COUNCIL ADDENDUM ASSESSMENT REPORT

HUNTER AND CENTRAL COAST REGIONAL PLANNING PANEL

Panel Reference	PPSHCC-245
DA Number	8/2016/557/2
LGA	Cessnock City Council
Proposed Development	<p>Section 4.55(2) Application proposing to modify Development Consent No. 2016/557 that approved a concept development application consisting of construction of an integrated tourist development to be completed in seven (7) stages - comprising an 18 hole golf course, 50 room hotel, 250 serviced apartments, 300 residential lots, function centre, aboriginal heritage centre, retail and food outlet, and spa and recreation facilities; and Stage 1 comprising a four (4) lot community title subdivision.</p> <p>The Section 4.55(2) Application proposes amendments to the layout and staging of the approved development, along with a modification to the number of community title lots proposed to be registered in conjunction with Stage 1 of the concept approval.</p>
Address	<p>Wine Country Drive (Lot 1 DP 1233030)</p> <p>Wine Country Drive (Lot 2 DP 869651)</p> <p>1058 Wine Country Drive (Lot 3 DP 869651)</p> <p>1054 Wine Country Drive (Lot 4 DP 869651)</p> <p>1184 Wine Country Drive (Lot 11 DP 1187663)</p>

Author

Figure 2 - Concept and Management Plan (prepared by Hunter Development Brokerage Pty Ltd, Revision 6, dated 13 May 2024)

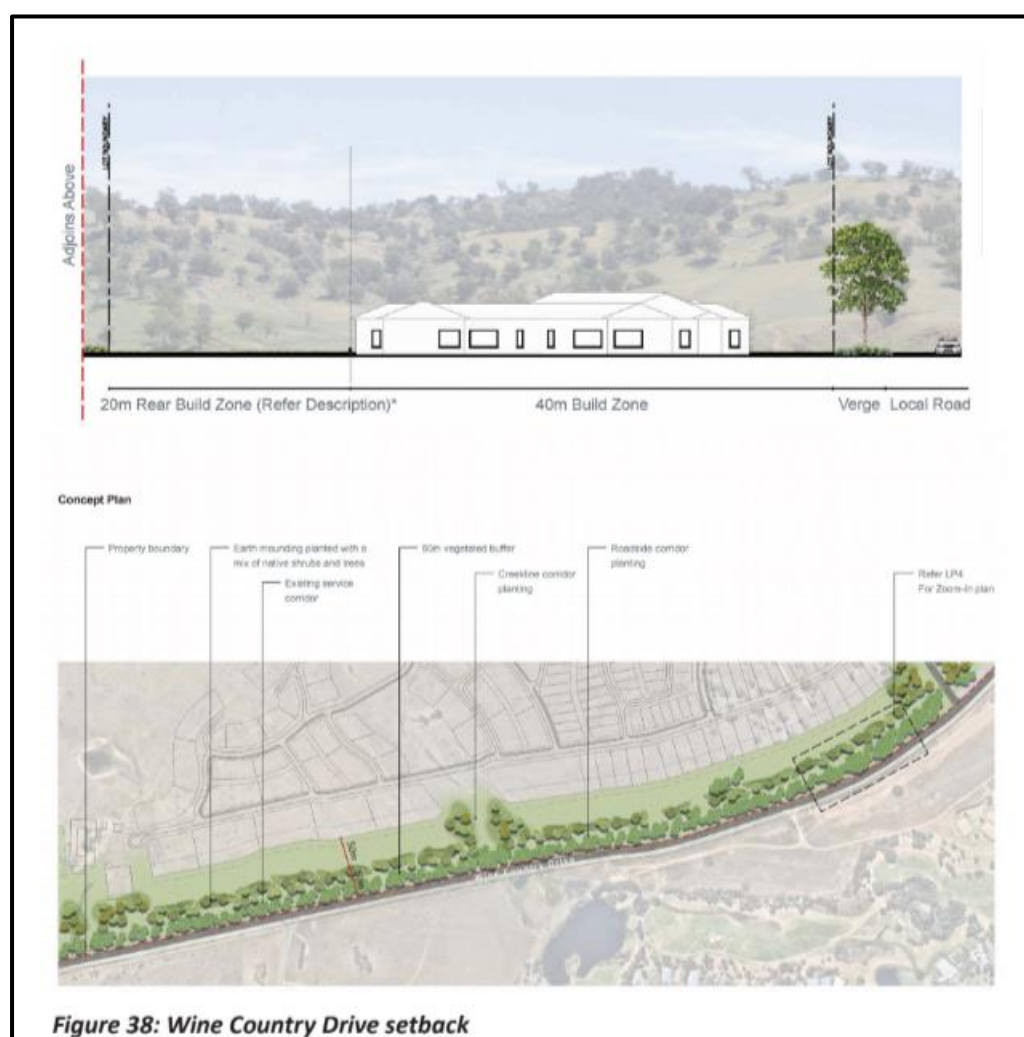
A vegetated buffer will be established within the first 50 metres of the setback from Wine Country Drive, and this will be landscaped in accordance with the Landscape Plan. The remaining 50 metres will be retained in Lot 1, i.e., as community property. In addition, a 20 metre 'rear build zone' will be established whereby only non-habitable structures limited in height to 3.1m will be permitted. This restriction is contained within the draft Community Management Statement. The 'build zone' for residential dwellings on the affected lots will be 40 metres in depth. This is illustrated below.

Figure 3: Community Title Subdivision Plan (prepared by Monteath & Powys, Revision 17, dated 23 March 2024)

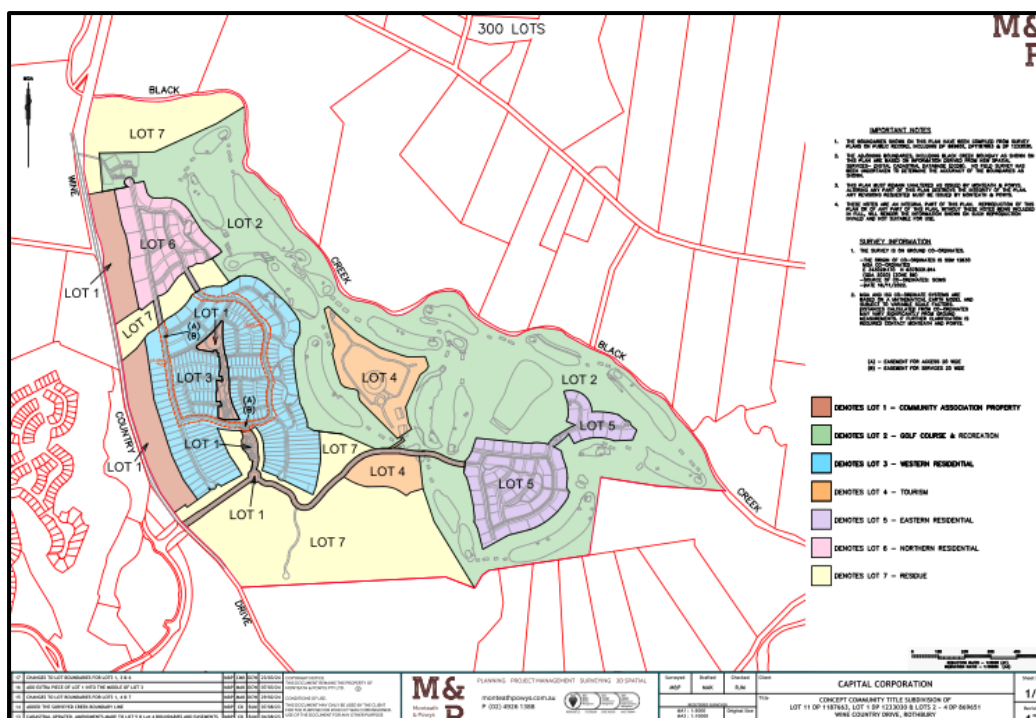
The 100-metre setback area has been incorporated into Lot 1, and the Community Title Subdivision (prepared by Monteath & Powys, Revision 17, dated 23 March 2024) has been updated to reflect this, as illustrated below.

Council officers have reviewed the amended plans and documentation and are satisfied that it adequately addresses the issue raised by the Panel.
